# **3 Volt Intel<sup>®</sup> Advanced+ Boot Block Flash Memory**

**28F800C3, 28F160C3, 28F320C3, 28F640C3**

*Specification Update*

Order Number: 297938-014

## 1. 28F320C3xC Maximum $I_{CCE}$ when $V_{pp}=12V$

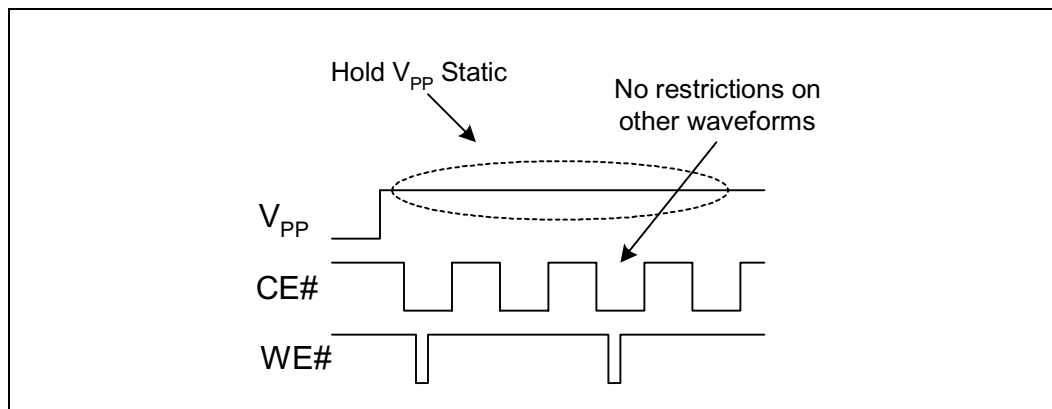
**Problem:** When  $V_{PP}=12V$ ,  $I_{CCE}$  Max on 28F320C3xC devices on the 0.18 $\mu$ m deviates from the published specification and increases from 15mA to 25mA. The following is the revised specification for these products.

**Implication:** The increased current requirements may result in increased power drawn from the power supply during limited 12 V production programming. 3 V programming is unaffected.

**Status:** 32-Mb devices on the 0.18mm process are affected.

## 2. 28F320C3xC Reset Failure

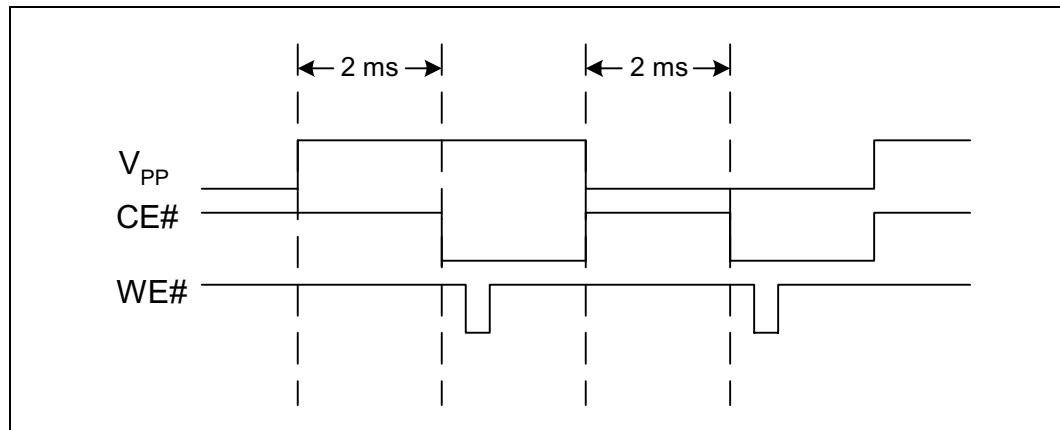
**Problem:** The 0.18 $\mu$ m 28F320C3xC devices can unintentionally reset under certain conditions where  $V_{pp}$  toggles.

**Implication:** When the reset occurs, any command being executed is interrupted and the flash switches to read array mode.

- 1) Tie  $V_{pp}$  to  $V_{CC}$ ;
- 2) If the third and fourth digits on the top side FPO mark (third line) is equal or greater than “23”, then  $V_{CC}$  may be set from 2.7v to 3.3v.  $V_{CC}$  must not exceed 3.3v
- 3) Set  $V_{pp}$  to a static high or static low level as shown here; and

4) Wait 2 ms after a  $V_{PP}$  transition to access the flash device, as shown here.

Figure 1. Workaround Placement

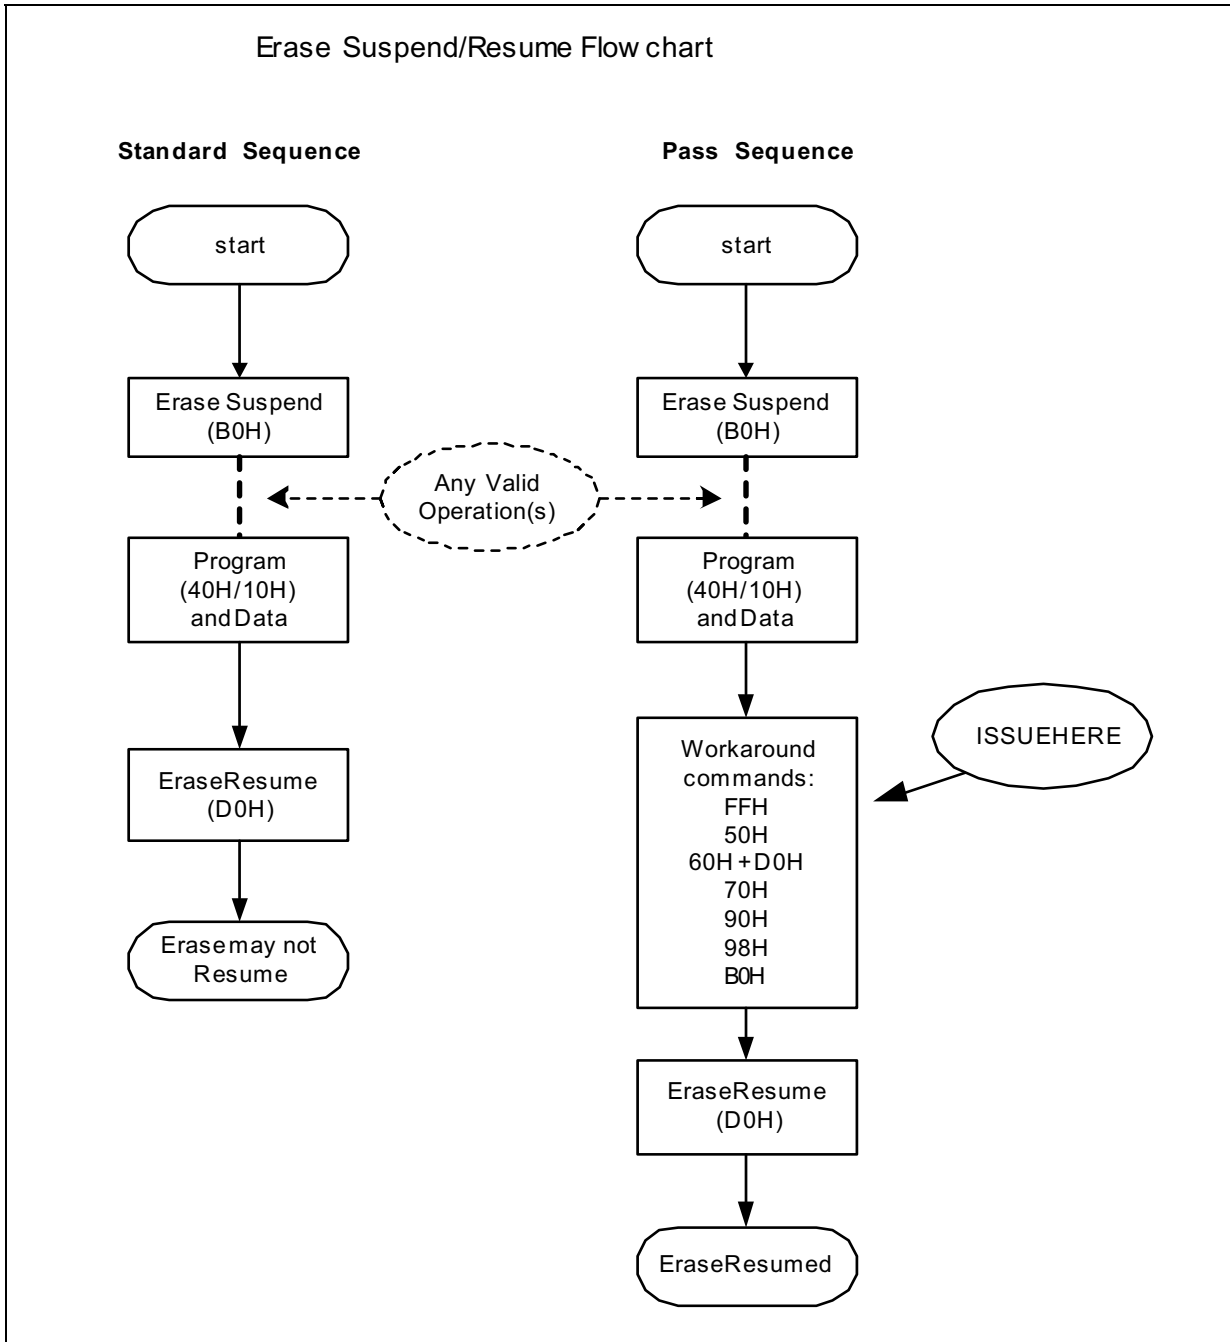
**Problem:** On the 0.18µm 28F160C3xC devices, a design anomaly was discovered. During an Erase-Suspend operation, if the Program (40H/10H) sequence is executed, under limited conditions the proceeding Erase Resume command (D0H) may not actually resume the device. No customers have reported failures in product applications. Customers who use any version of FDI (Intel Flash Data Integrator) software will not see this issue. If the Read Array command is issued prior to the Erase Resume command, users will not see the issue (typical in XIP applications).

**Implication:** The Resume Command (D0H) may be ignored by the device and will not correctly resume. The device will appear to remain in suspend (via status register). After a reset of the flash device the status register will clear. This failure has been recreated in a lab environment only.

1. If FDI (Intel Flash Data Integrator) software is used, users will not see the issue.
2. During an Erase-Suspend (B0H), user must issue any of the following commands after issuing the Program (40H/10H) and data sequence but before issuing the Erase-Resume (D0H) command.

**5. 28F160C3xC and 28F640C3xC Lock/Unlock/Lock-Down Operation**

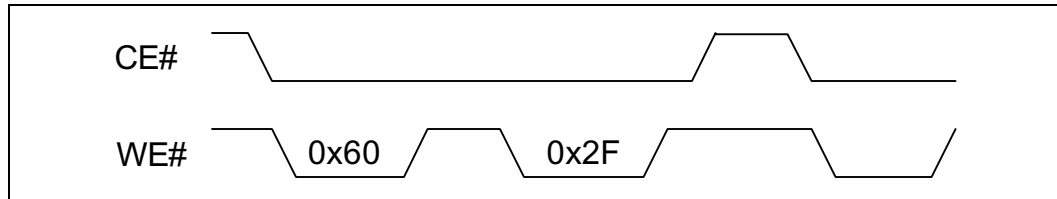
**Problem:** On the 16Mb and 64Mb 0.18µm devices, if CE# is deasserted after any block lock operation and before the next write sequence, the part may perform the same operation on additional blocks. (See waveform below.)

**Implication:** When CE# is deasserted after performing a block lock operation to a specific block and prior to the next write sequence, other blocks may perform the same operation.
